# Barrow County Board of Commissioners

## MEMORANDUM – ADDENDUM NO. 2

**Re:** RFB2015-5 – Sports Lighting – Victor Lord Park – Addendum No. 2

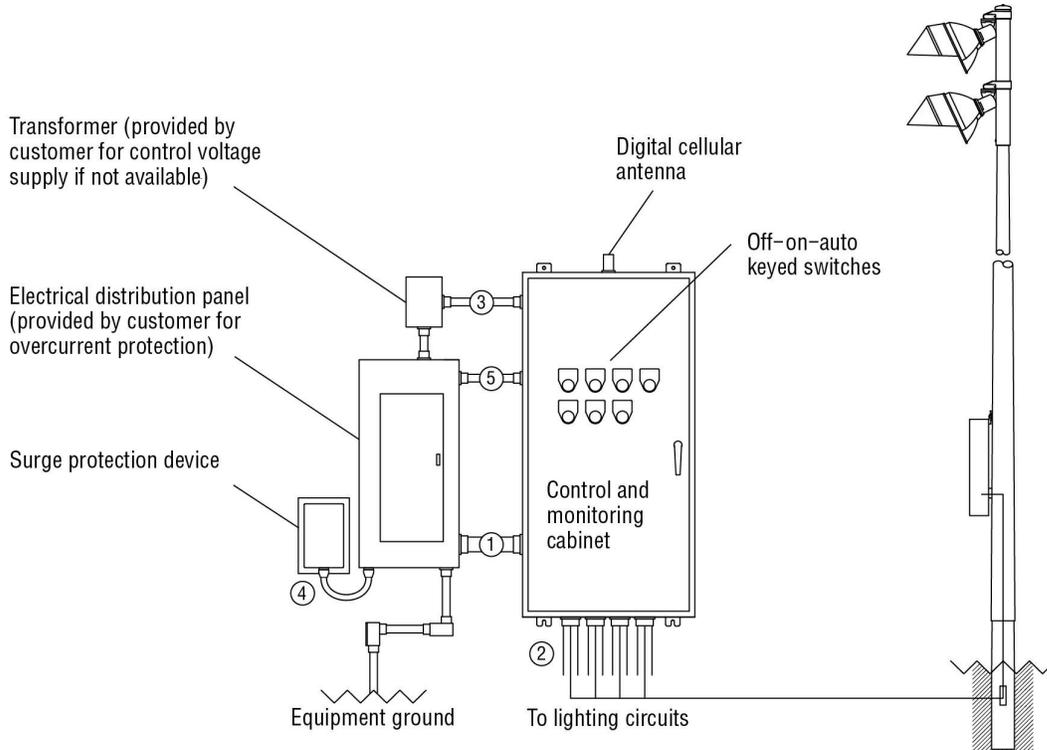
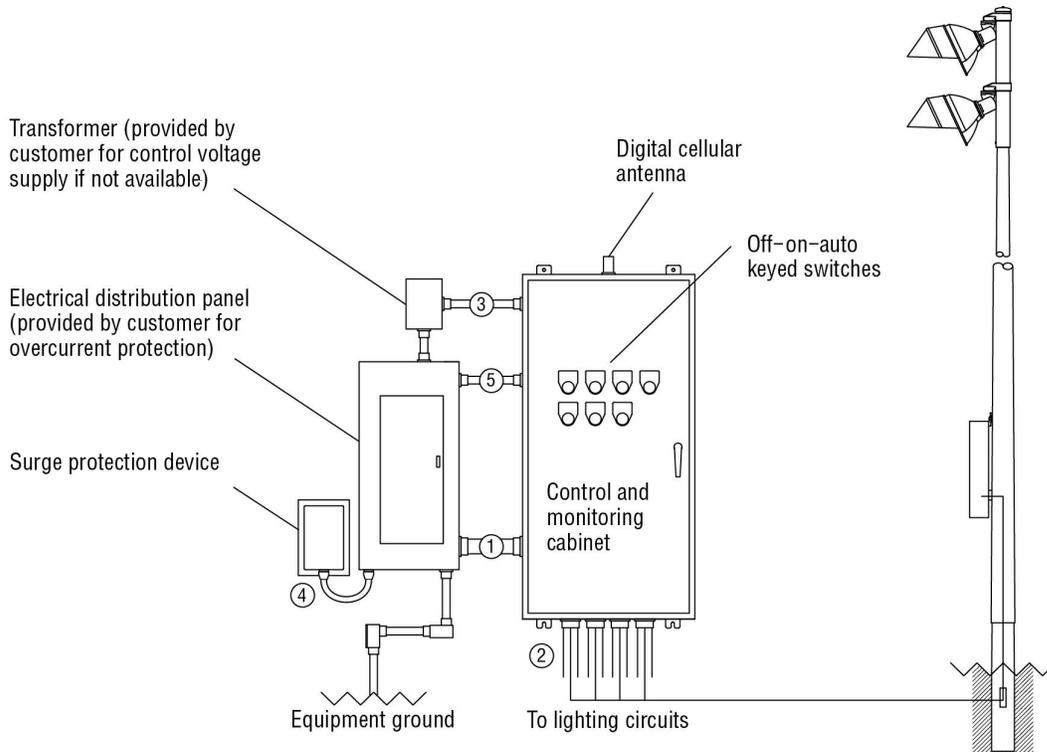
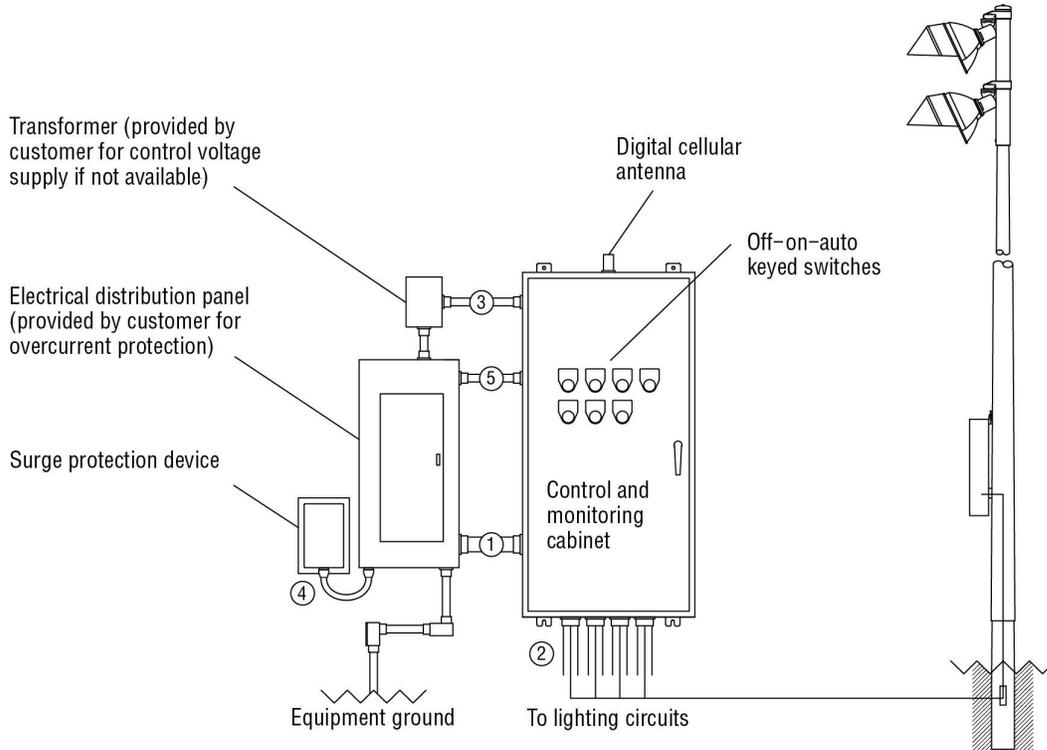
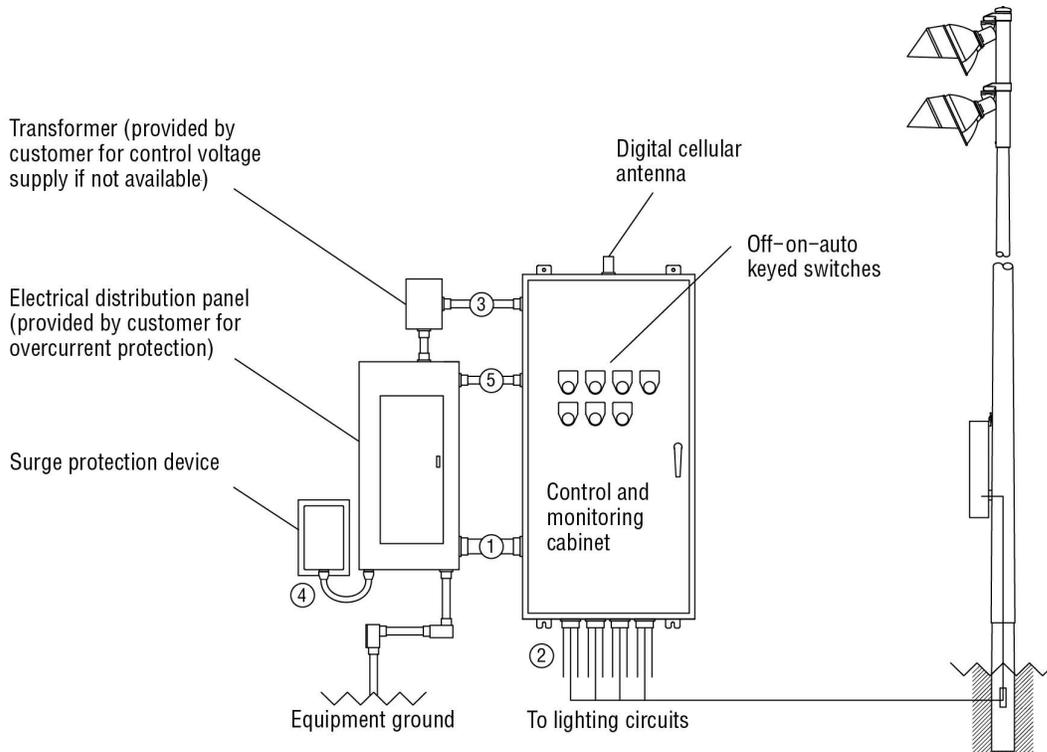
4. Transformer located on Field 7 is 120/208Y. Is this transformer to service both fields, if so are we to use existing service wire from that transformer to field 8?

Yes; Use existing service wire from that transformer to field #8. If existing phase is used.  
**(See attached revised Control Summaries – Voltage and Phase)**

Original bid docs assumed 480 volt 3 phase for all.

**Option 1:**

**Field 7 - 208 volt 3 phase**

**Field 8 - 480 volt 3 phase (if option 1 is taken - there will be no need for question 3)**

**Option 2:**

**Field 7 - 208 volt 3 phase**

**Field 8 - 208 volt 1 phase**

If Option #2 re-use service wire from main distribution (located at field #7) to secondary service to field #7).
